ENGINEER'S CUT LDIN STA 65+53 TO STA 69+91

REV	APPROVED DATE	DESCRIPTION	JCN	REDLINE DATE	APVD
DEPARTMENT OF TRANSPORTATION FEDERAL AVIATION ADMINISTRATION ATO - TECHNICAL OPERATIONS WESTERN SERVICE AREA					
LDIN RWY 08 - ENGINEER'S CUT REPLACE LDIN STATION 65+53 TO 69+91 - LAYOUT					
JUNEAU		JUNEAU INTERNATIONAL AIRPORT		AK	
REVIEWED BY	SUBMITTED BY	APPROVED BY			
		<i>Maria S. Clark</i>			
PROJECT ENGINEER		MGR: CONSTRUCTION/INSTALLATION			
DESIGNED	ISSUED BY	DATE	JCN	1004011	
DRAWN	ENGINEERING SERVICES	11/19/2011		REV	
CHECKED	NAVAIDS	JNU-D-LDIN-C205

DWG. 44.0-L

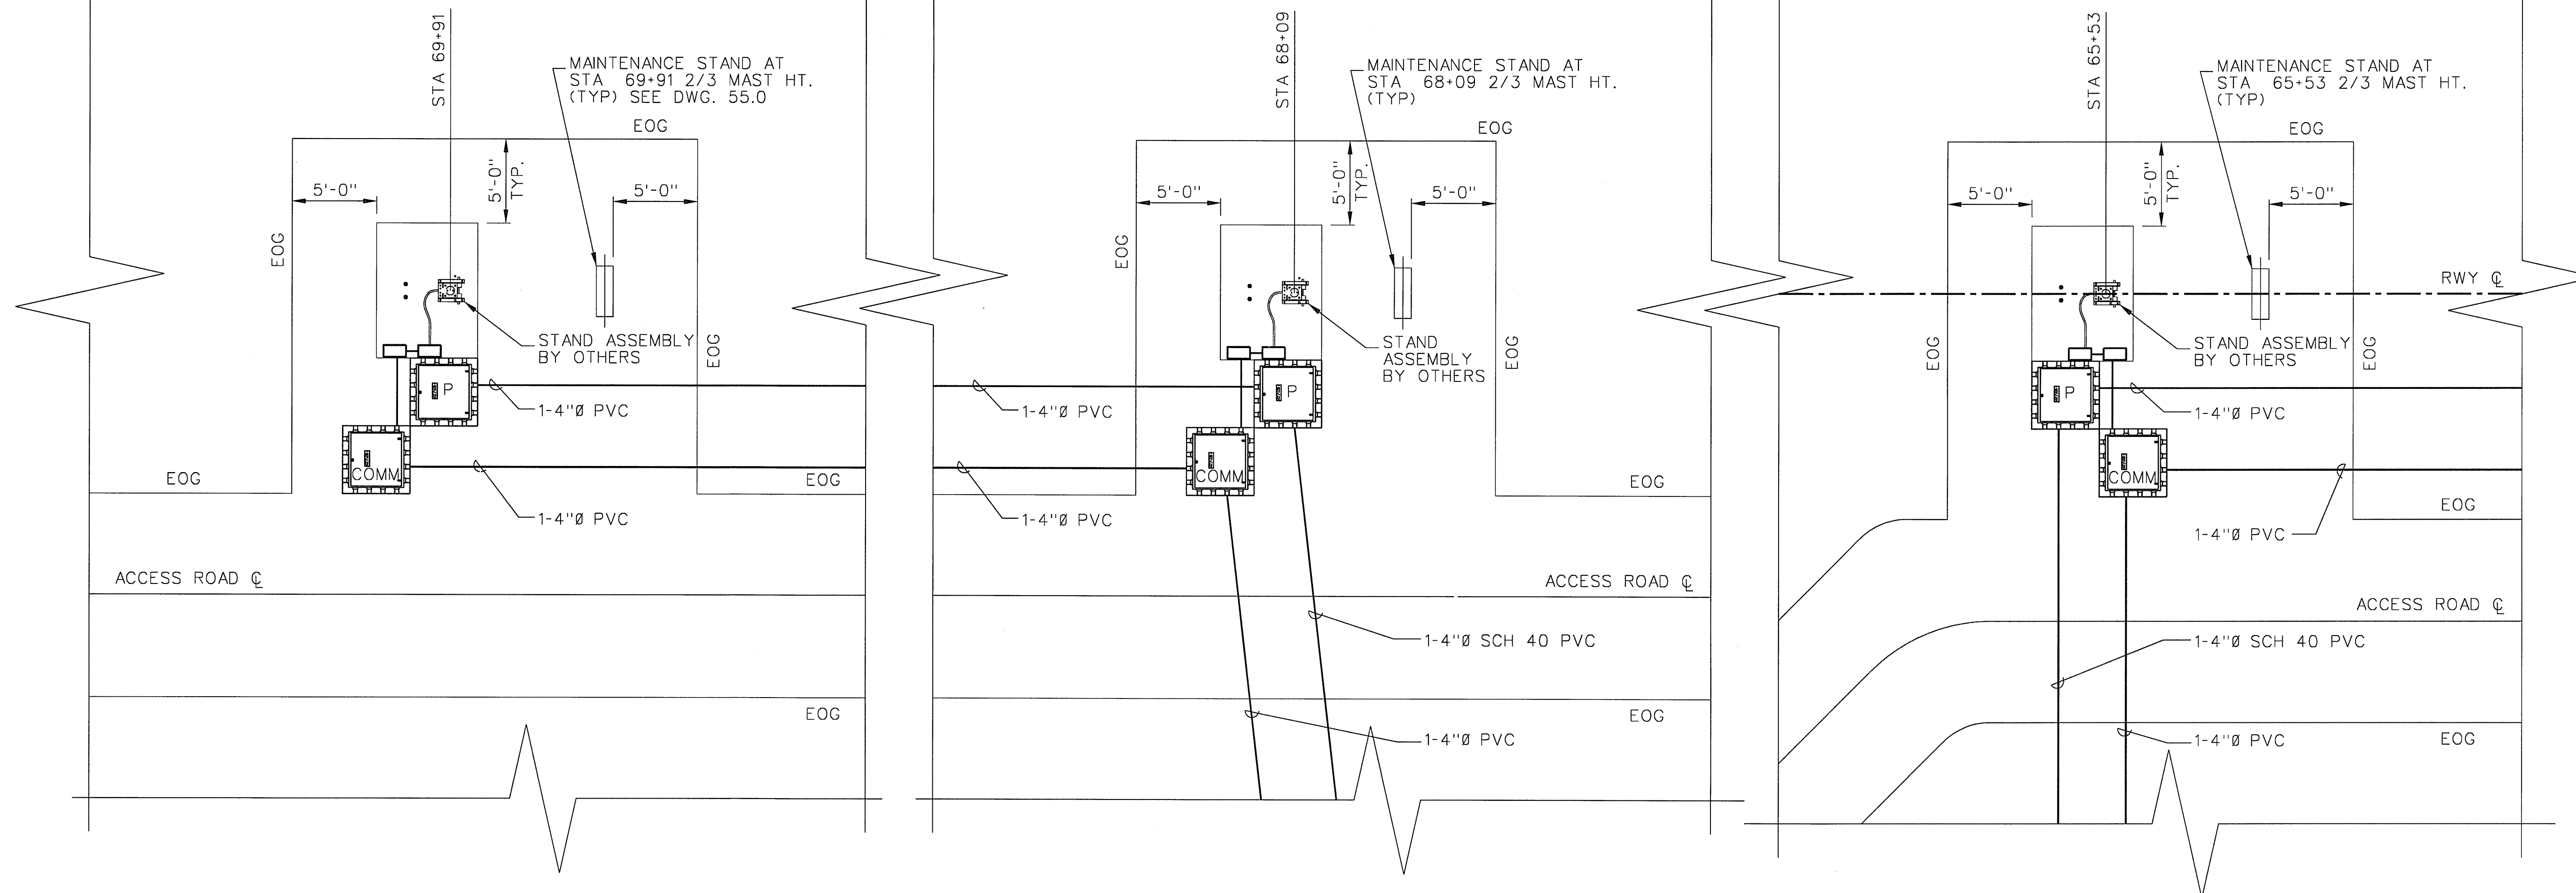
1. ALL UNUSED CONDUITS WILL HAVE A PULL STRING IN EACH INTERDUCT.
2. MAINTAIN A MIN. 6" SEPARATION BETWEEN POWER AND CONTROL (TYP)
3. MAINTAIN A MIN. 3ft SEPARATION BETWEEN POWER AND CONTROL CONDUITS
4. ALL DUCT BANK UNDER GRAVEL ROADS SHALL BE CONCRETE ENCASED A MIN. OF 4" COVER.
5. ~~THE EXISTING LDIN SYSTEM SHALL REMAIN OPERATIONAL WHILE THE NEW LDIN IS BEING CONSTRUCTED.~~
6. ~~THE NEW LDIN SYSTEM WILL BE COMMISSIONED IN SUMMER 2012.~~
7. ~~ONCE THE NEW LDIN SYSTEM IS COMMISSIONED, THE OLD LDIN SYSTEM SHALL BE COMPLETELY DEMOLISHED AND SITE RESTORED.~~
